Intel® Pentium® 4 Processor

Specification Update

November 2003

Document Number: 249199-044

Table System Bus AC Specifications (Reset Conditions)

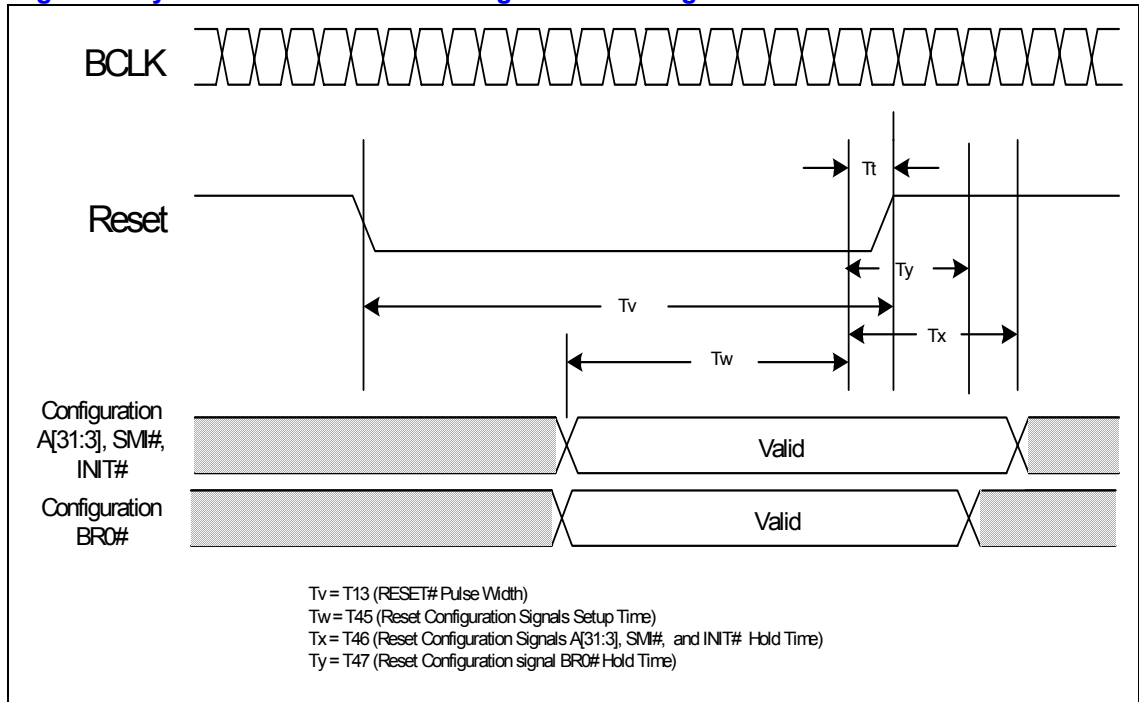
N2. BR0# Maximum Hold Time Specification Change

The BR0# maximum hold time has changed to 2 BCLKs. This change will be shown in the “System Bus AC Specifications (Reset Conditions)” table and “System Bus Reset and Configuration Timings” figure of the Intel(R) Pentium(R) 4 Processor with 512KB L2 Cache on 0.13 Micron Process EMTS & Intel(R) Pentium(R) 4 Processor in the 478-pin Package Electrical, Mechanical, and Thermal Specifications (EMTS) & Intel(R) Pentium(R) 4 Processor in the 423-pin Package Electrical, Mechanical, and Thermal Specifications (EMTS). These changes will be incorporated in the next revision of the EMTS (Datasheet).

T# Parameter	Min	Max	Unit	Figure	Notes
T45: Reset Configuration Signals (A[31:3]#, BR0# INIT#, SMI#) Setup Time	4		BCLKs	12	1
T46: Reset Configuration Signals (A[31:3]#, INIT#, SMI#) Hold Time	2	20	BCLKs	12	2
T47: Reset Configuration Signal BR0# Hold Time	2	2	BCLKs	12	2
